DeltaPSU Product Notice

Medical MDS-250, MDS-300 and MDS-400 Series Product Change Notice

1. CN101 Connector Change

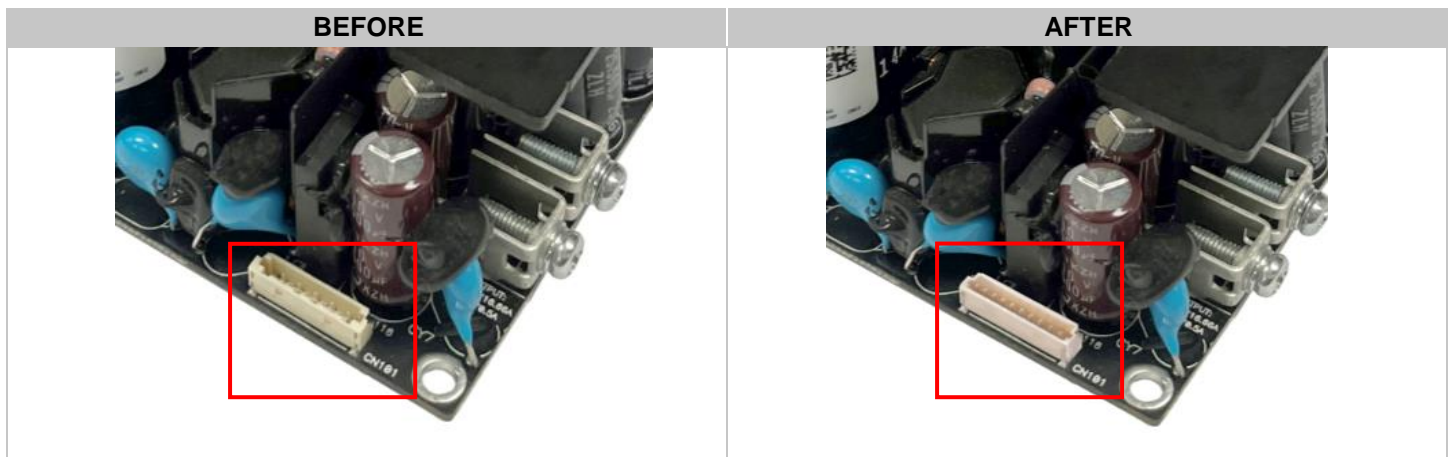
Control connector (CN 101) from Molex used in MDS-250, MDS-300 and MDS-400 medical power supply series will be obsolete (EOL). Delta will hence change connector manufacturer from Molex to JST.

BEFORE	AFTER
PCB Side Molex 104141-1010 Rating : DC50V/1A	PCB Side JST BM10B-SRSS-TB1(LF)(SN) Rating : DC50V/1A
System Side Housing : Molex 1041421000 Terminal : Molex 1045398002	System Side Housing : JST SHR-10V-S-B & SHR-10V-S Terminal : JST SSH-003T-P0.2-H
